City of El Paso - City Plan Commission Staff Report

Case No: SUSU17-00082 Montana Commons

Application Type: Resubdivision Combination

CPC Hearing Date: February 8, 2018

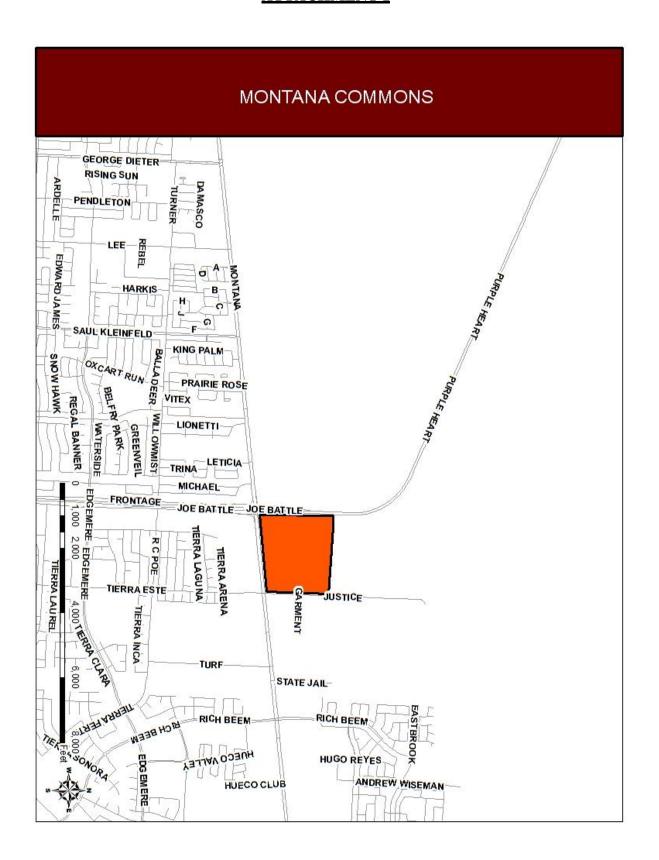
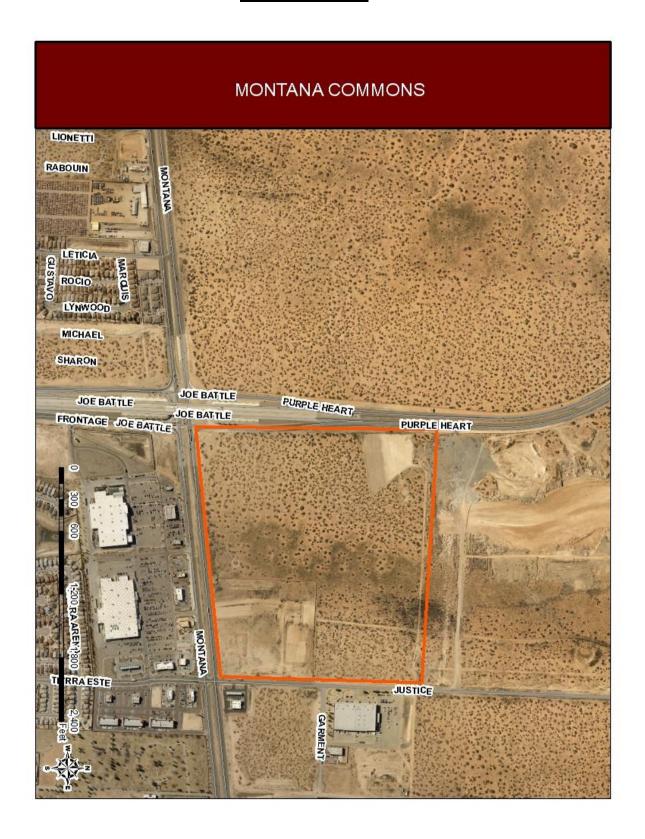
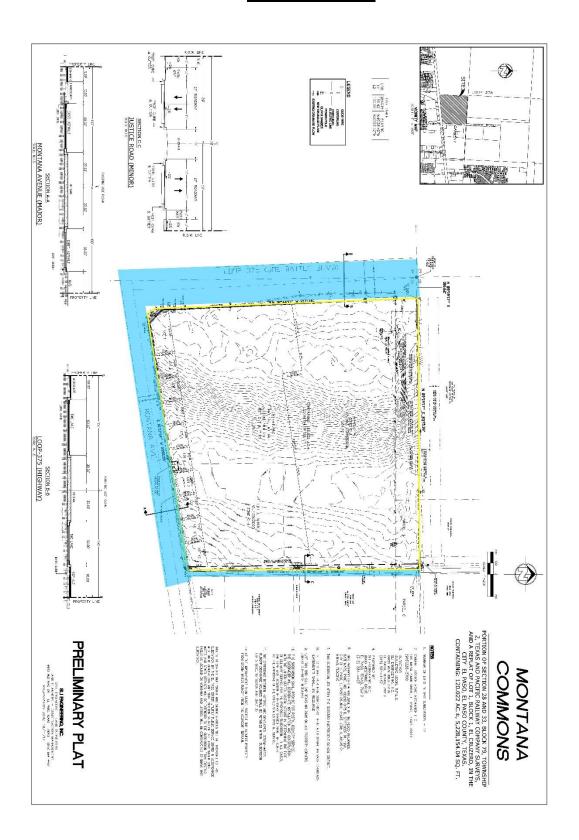
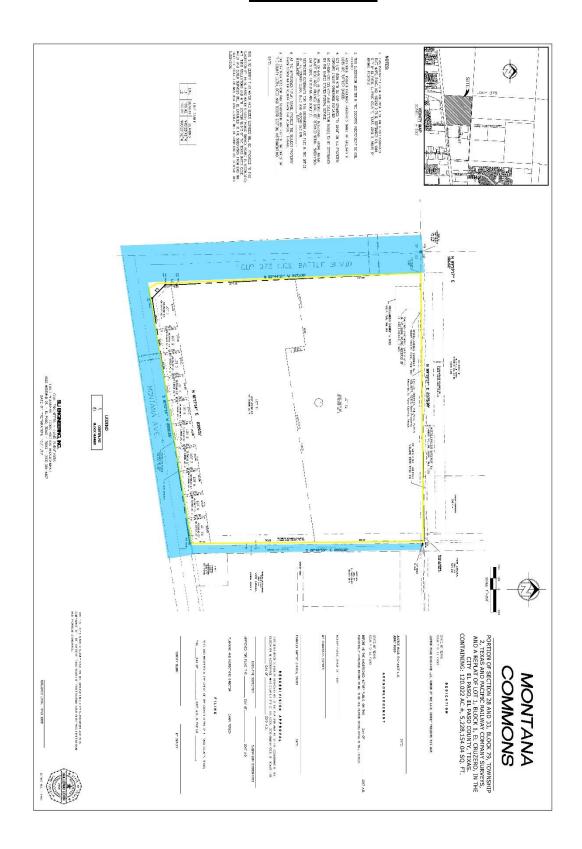
- 1. Existing 30' PSB easement located north of and parallel to Montana shall be shown in the plat.
- 2. EPWater requires the dedication of a 30-foot easement along the entire Joe Battle Frontage.
- 3. EPWater requires a complete set of improvement plans, and grading plans for review and approval prior to any work pertaining to the portion of the property where the existing 30-foot PSB easement is located. This is required in order to ascertain that the proposed improvements and/or grading will not adversely affect the mains that extends along a portion of the easement. Also, the Developer shall minimize changes in grade above or near the vicinity of the existing facilities.

- Remove the Joe Battle Blvd from the plat or will Joe Battle Blvd be extended north of Montana?
- Loop 375 and Joe Battle are not the same road. Please revise.
